# **Peer Review of the United Water Conservation District and Calleguas Municipal Water District Models for the Oxnard Subbasin, Pleasant Valley Basin, and Las Posas Valley Basin**

## **Fox Canyon Groundwater Management Agency**

## **MARCH 2019**

Figure 8-6 Recharge (in/year) for January, 1970

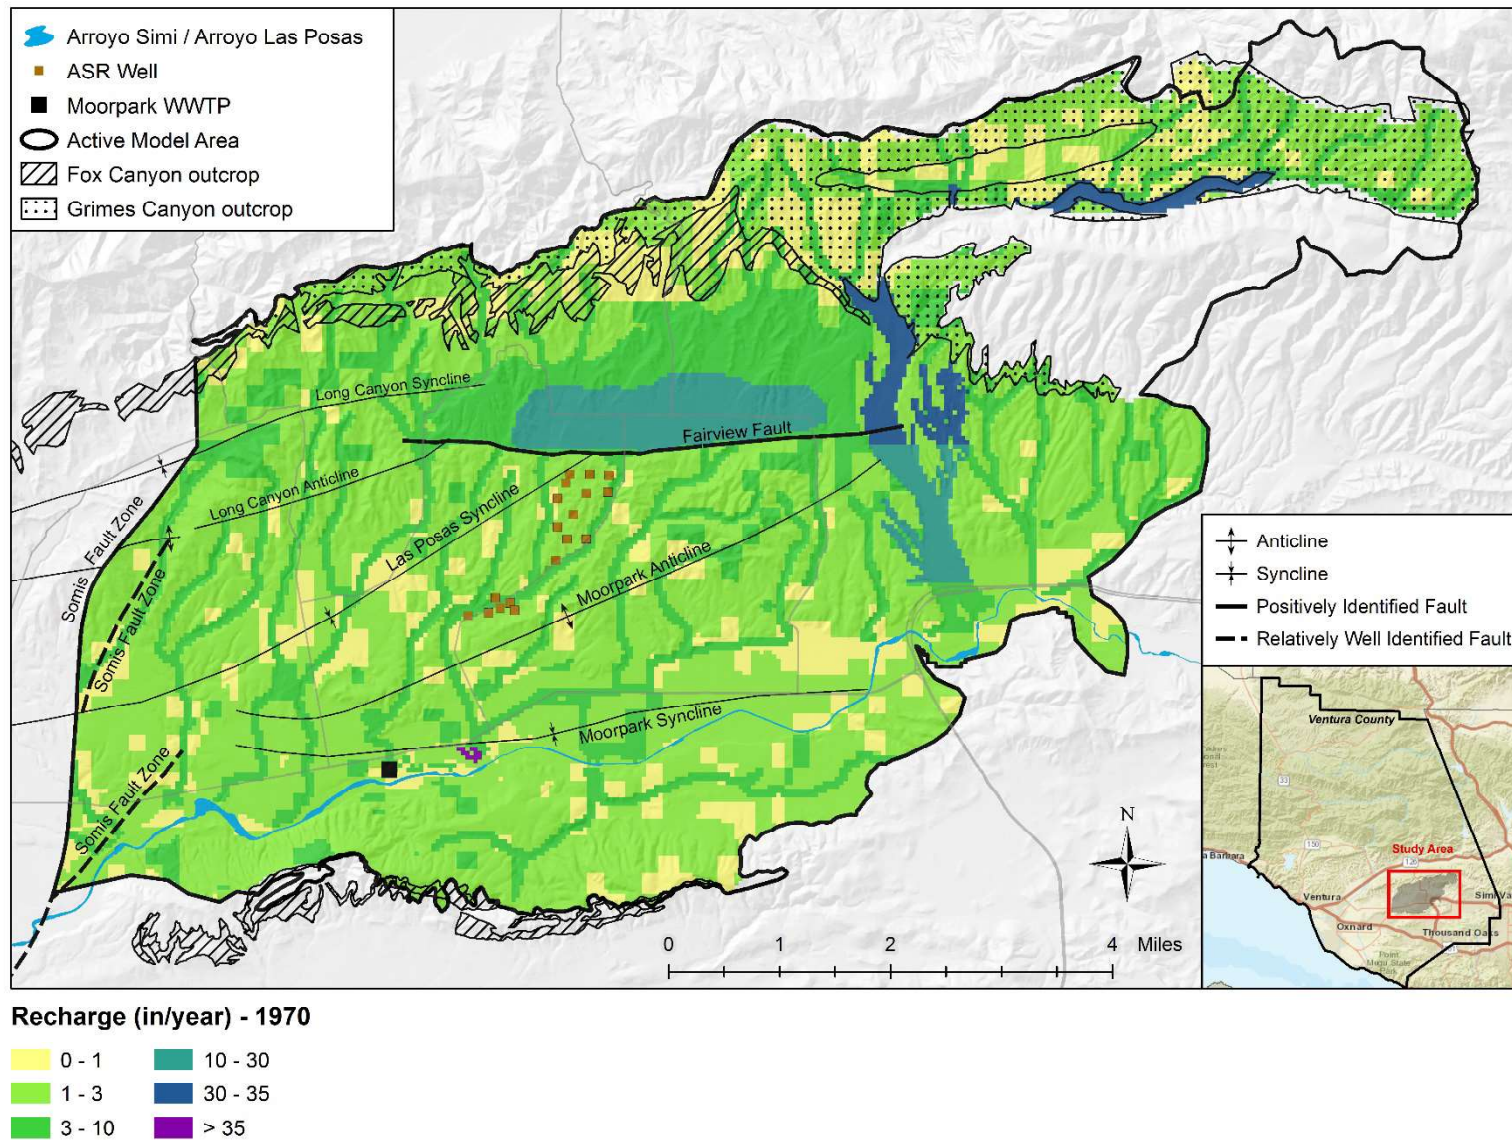
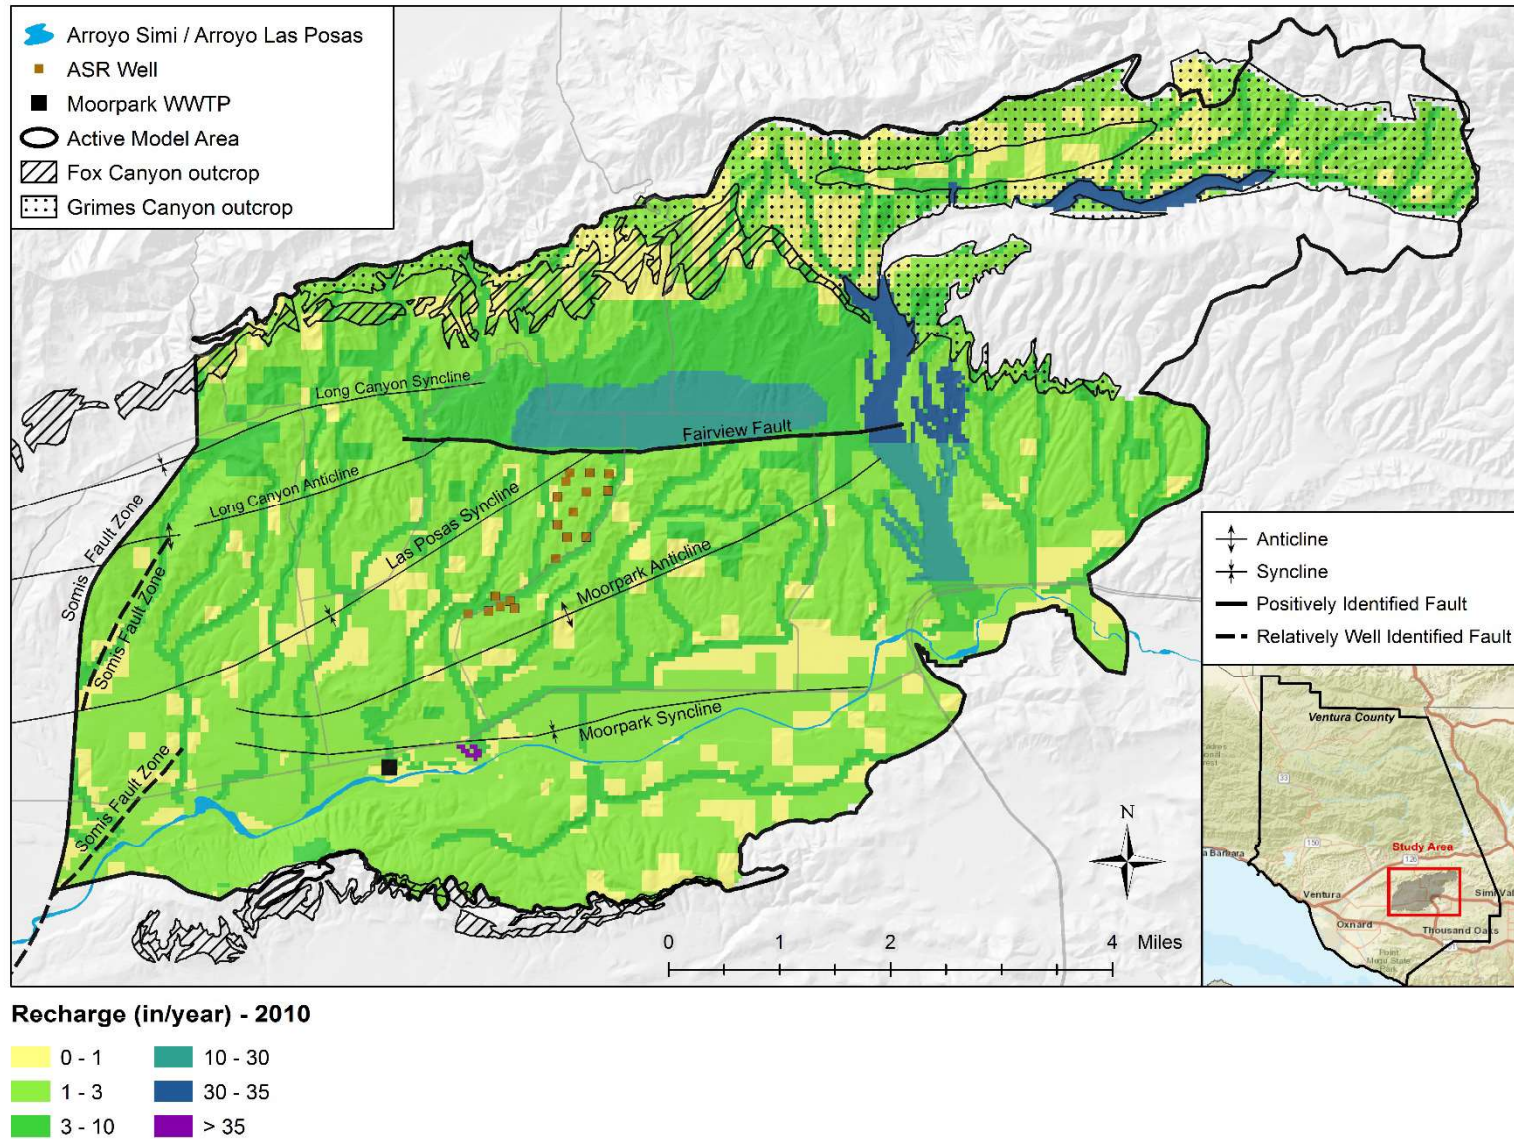
The model incorporates recharge to the Grimes Canyon aquifer in the outcrop area in the northeastern portion of the model. CMWD Figures 8-6 and 8-7 in Appendix B show parts of the outcrop area where drainage channels receive 30-35 inches per year of recharge. There are no stream gauges in this area, nor wells to constrain this assumption. There is also no data to guide the assumed thickness of the Grimes Canyon aquifer in this area. Simulated heads in this area of the model rise from initial heads of 1,000 to 7,000 ft msl (CMWD, 2018: Fig. 8-55) in January 1970 to 1,000 to 14,500 ft. msl in January 1990 to 1,000 to 22,000 ft msl in January 2015. Simulations of future conditions produce heads of approximately 29,000 ft msl. While these simulated heads are unrealistic, different assumptions about aquifer thickness and specific storage could change them dramatically.

Figure 8-55 Layer 7 (GCA) hydraulic heads (ft amsl) – Jan 1970 (Stress Period 1)

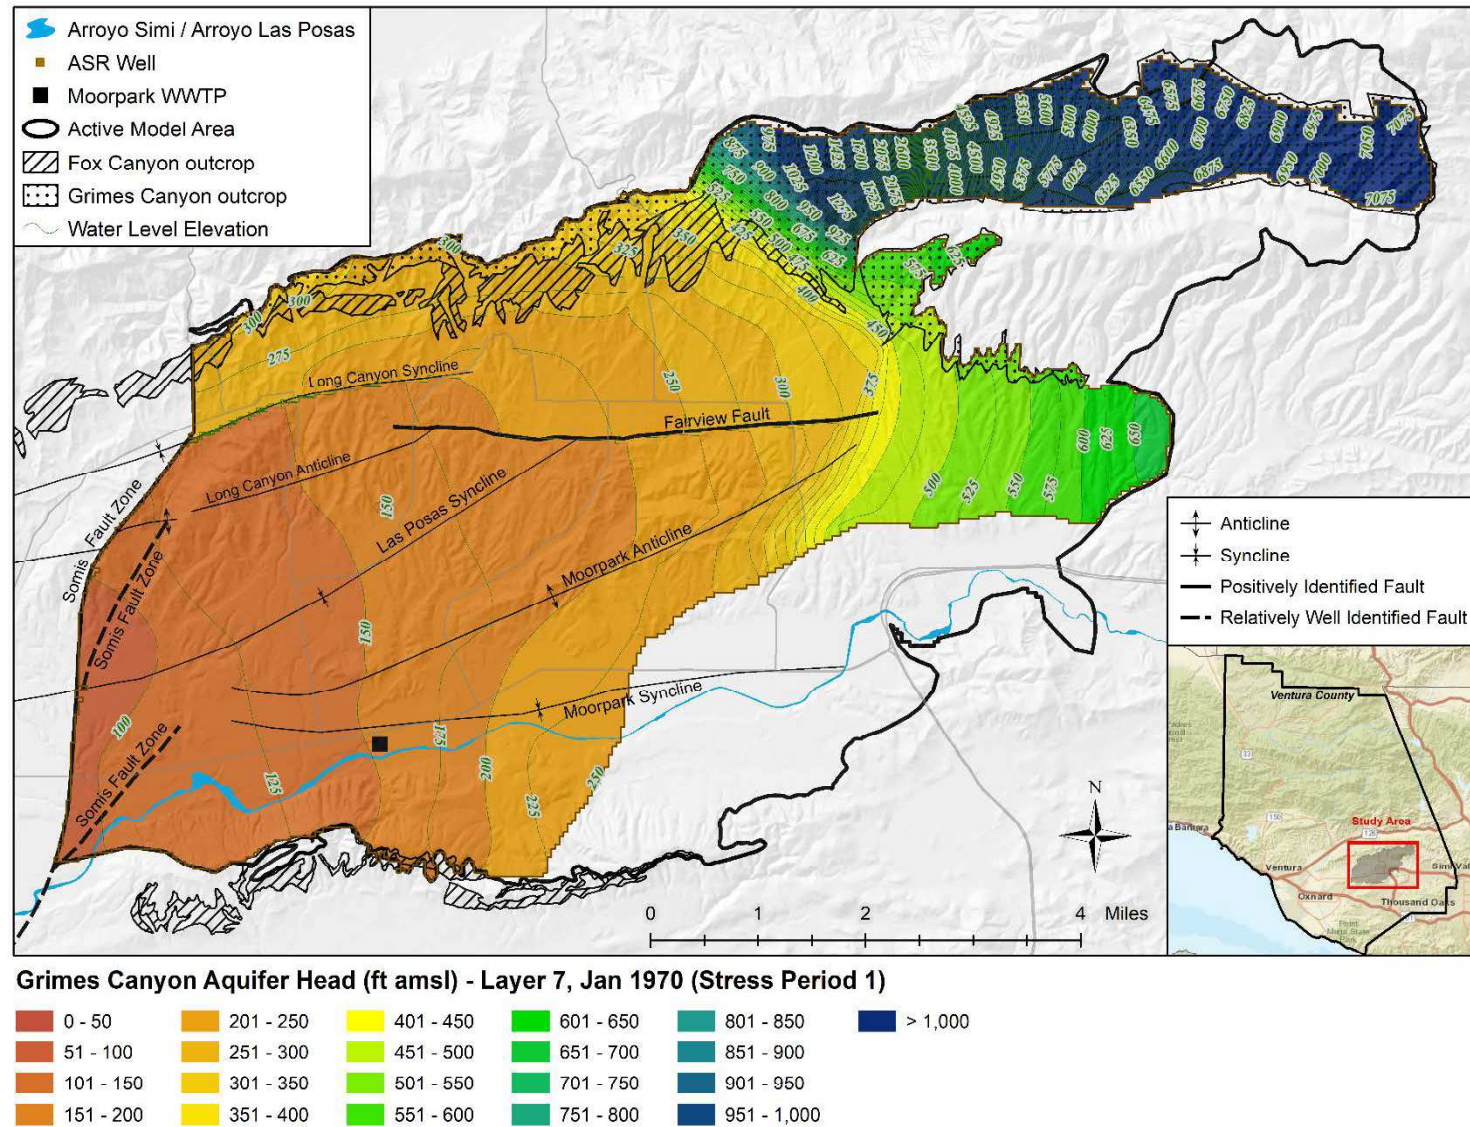
Examining the historical production from the Grimes Canyon Aquifer and the modeled impacts of the excessive predicted heads in the Grimes Canyon Aquifer, the uncertainty regarding modeling of the entire ELPMA is small. Over the next 5 years, hydraulic properties and recharge to the Grimes Canyon aquifer in the outcrop area should be investigated to constrain the estimated recharge. Geochemical evaluations might be useful in this regard.

Figure 8-58 Simulated versus observed hydrographs at key wells in the Shallow Aquifer (Layer 1)

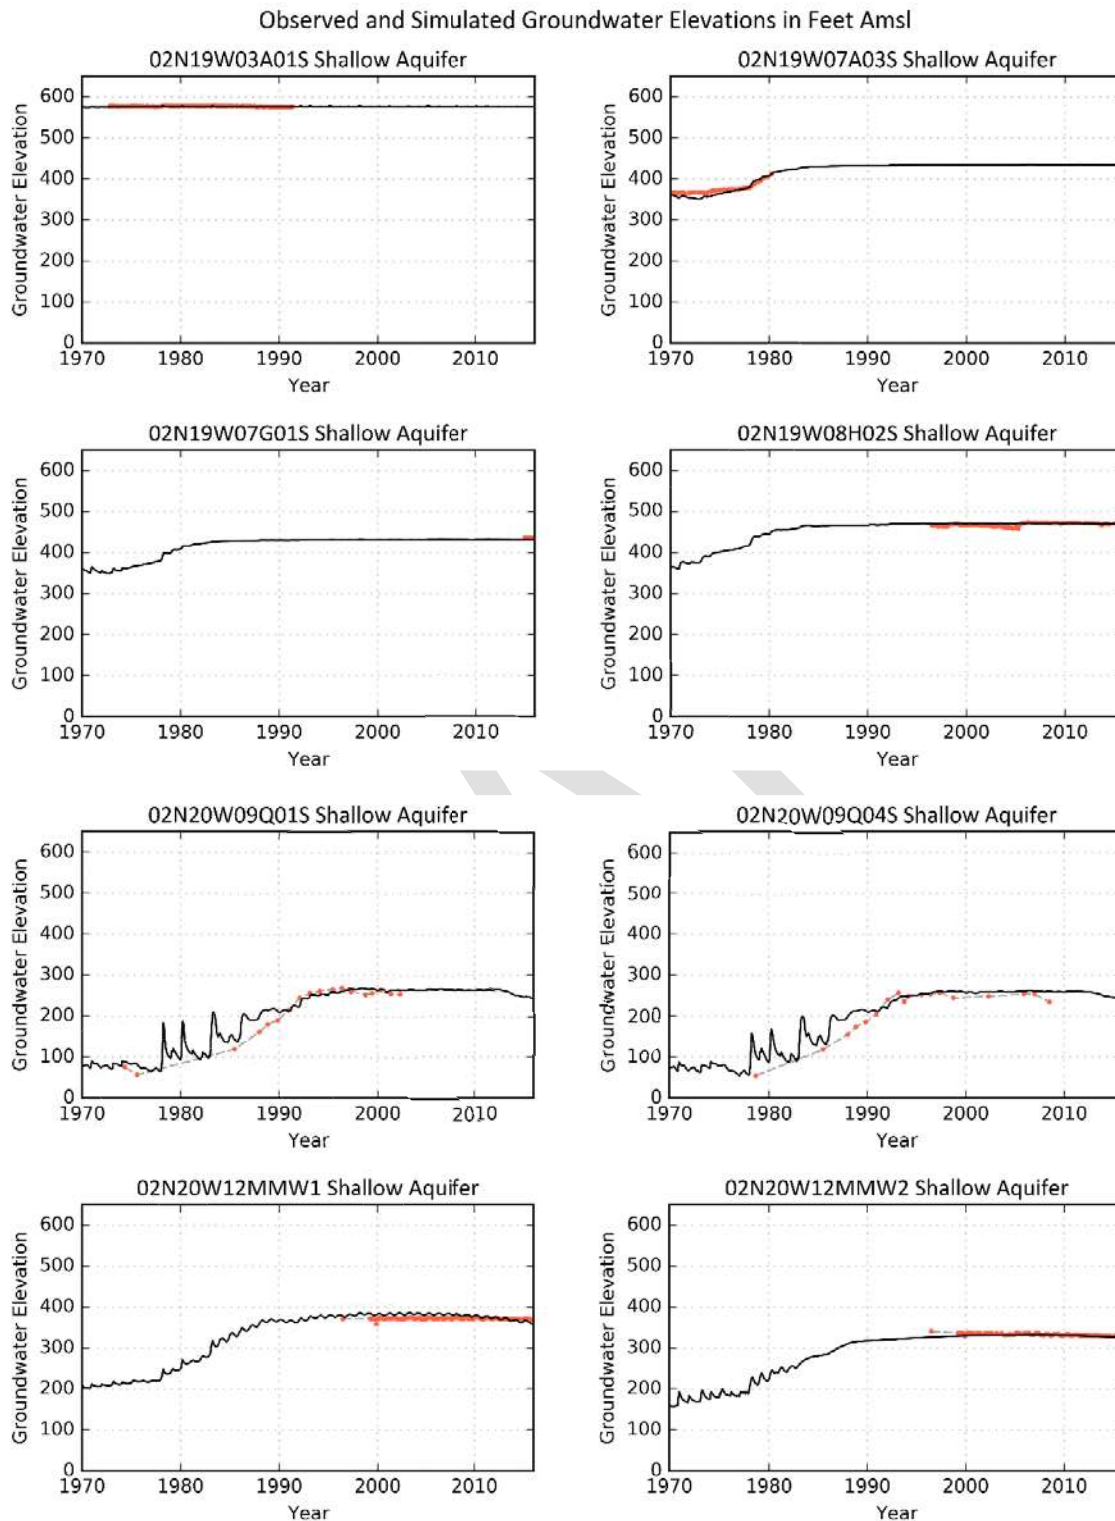
The model reproduces historical groundwater levels well in the shallow aquifer, USP, Fox Canyon, and Grimes Canyon aquifers in the central and southern portions of the ELPMA (See for example wells 02N20W09Q01S and 2N20W09Q04S on Figure 8-58, Figure 8-60, wells 02N20W09R01S, 02N20W10D02S, 2N20W10G01S, and others in Figure 8-62b, and 03N20W35R02S and 03N20W26R03S in Figure 8-63 – of the CMWD Model Documentation Report; also included as attachments in Appendix B). Simulated groundwater levels in the northern and northwestern area are not reproduced as well. There were fewer historical observations and greater uncertainty regarding well screens and the aquifers tapped by wells in the northwest. Simulated heads in Well 3N20W27B01S are a couple of hundred feet lower than observed (Figure 8-63 from the CMWD Model Documentation Report and included in Appendix B). Consequently, predictions of groundwater levels under future conditions are much less certain in the northwest of the ELPMA than they are in the center of the basin.
